Meeting Summary:

Conceptual Alternatives Meeting #2 - Discussion with Snohomish County Staff

MEADOWDALE BEACH COUNTY PARK FEASIBILITY STUDY

Meeting Date and Time: Thursday, February 26, 2015, 8:30 am to 10:30 am

Alternative 1: Three Span Bridge, Combined Creek and Pedestrian Access Route, 50% of Lower Lawn Converted to Habitat

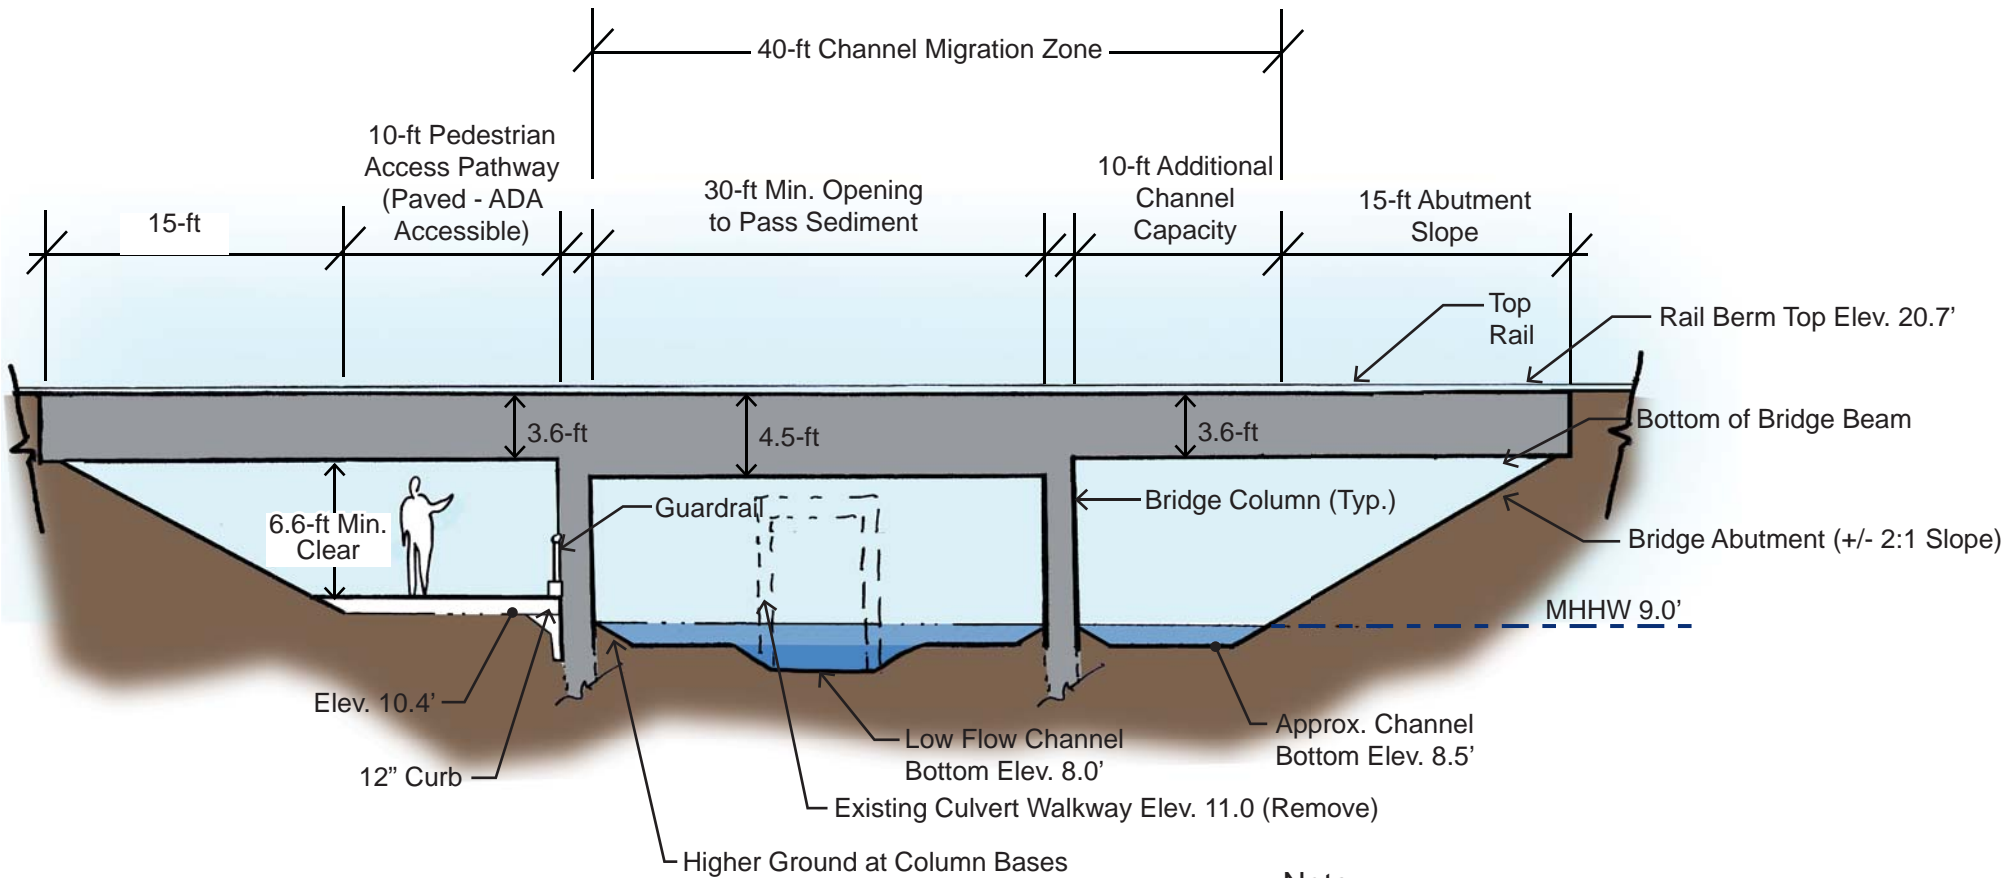
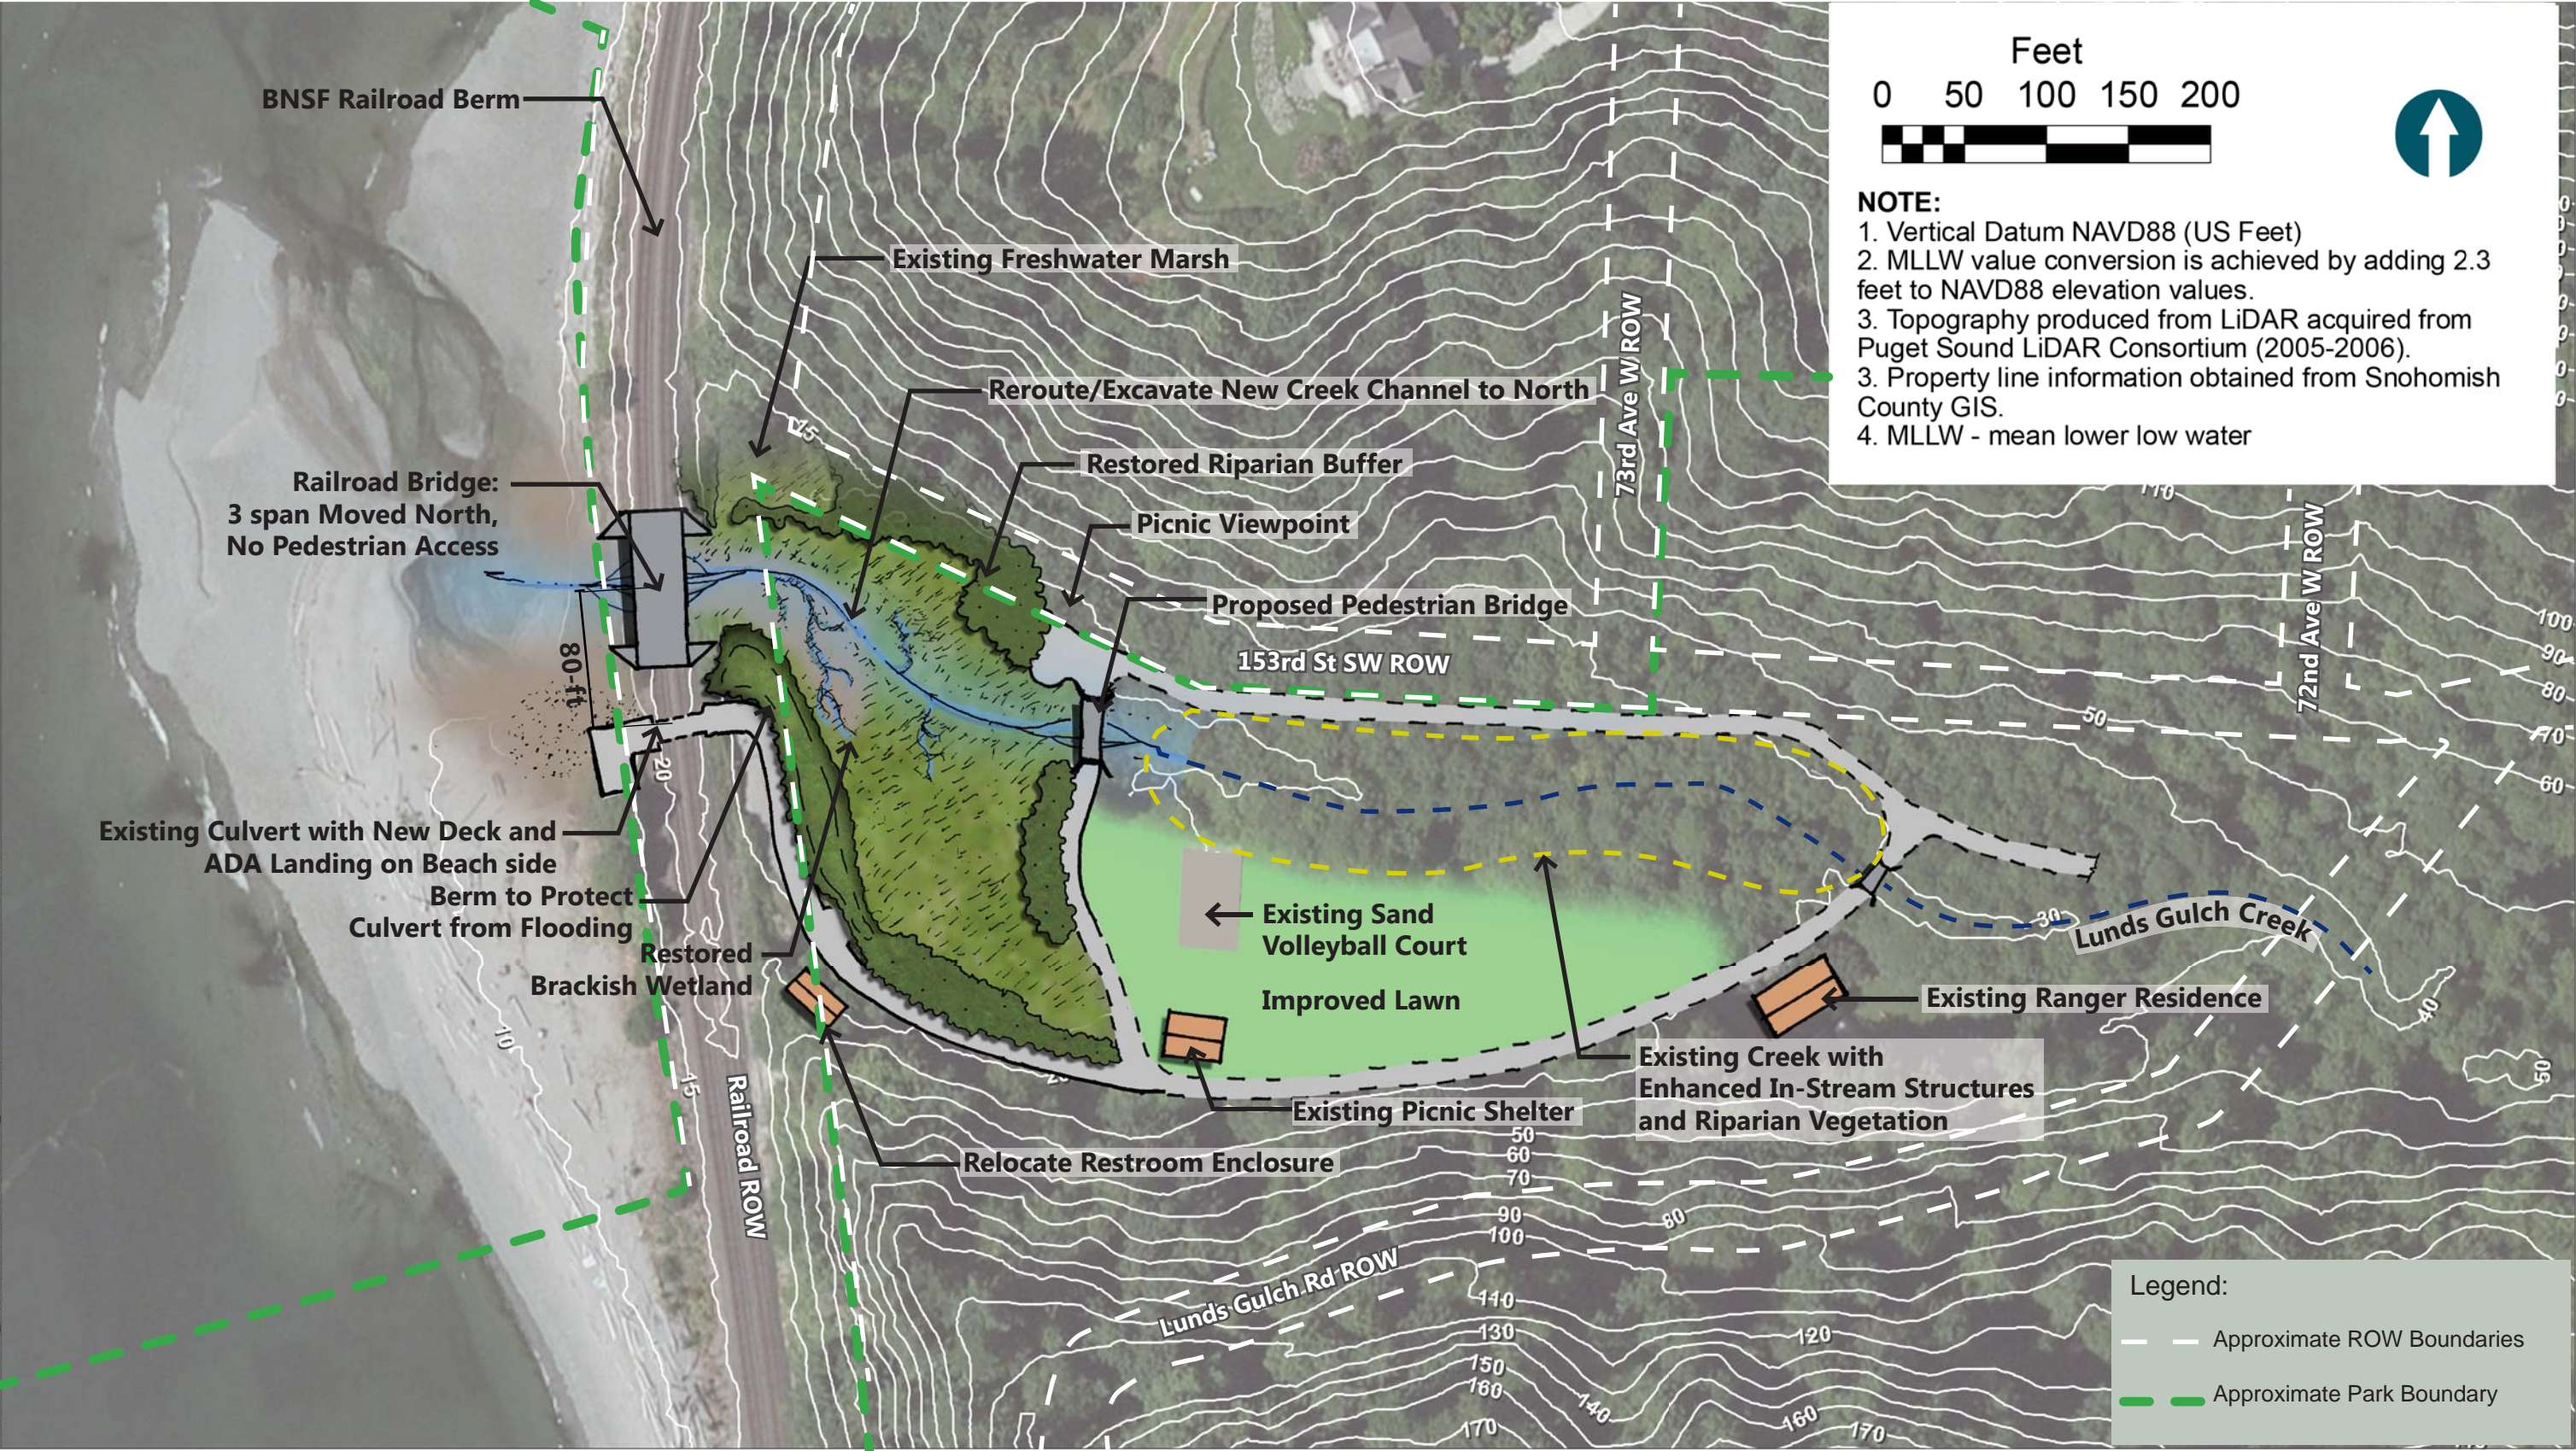
- Alternative 1: A three span bridge with a 25-foot clear span and two 25' abutment spans. Creek outlet provided through the clear span and the north abutment span. Pedestrian access provided in the south abutment span (10-foot walkway width). The walkway height would be optimized to provide up to 7 feet of vertical clearance; but would be inundated during higher tides.

- Vertical clearance and the elevation of the walkway for pedestrian access need to be precisely defined. It is important to understand how often the walkway (percent of the year) would be inundated by the tide at different elevations relative to allowed vertical clearance.

- “Dead-end” picnic areas shown on several of the alternatives at the terminus of the northern trail would provide benefit to large groups visiting the park, such as educational programs, by providing a place to congregate off the main trail. There is some concern that these terminus areas could provide a safety concern for the public. Therefore, they were removed from Alternative 2; but were left in Alternatives 1 and 3 for consideration and evaluation as part of the Recreation and ADA Needs study.

- The consultant team will revise plan and section views of proposed alternatives based on results of this meeting and will submit revised plan/section views for the three proposed alternatives to the County. Revised concept figures are provided in Attachment 1 to this meeting summary.
- The consultant team will move forward with all of the studies as outlined in the scope of work (Task 5) to evaluate feasibility of the three revised concepts.
- The consultant team will move forward with collecting survey data on site as required to fill data gaps (e.g. height of the rail, geometry of the existing tunnel, channel thalweg elevations, etc.).
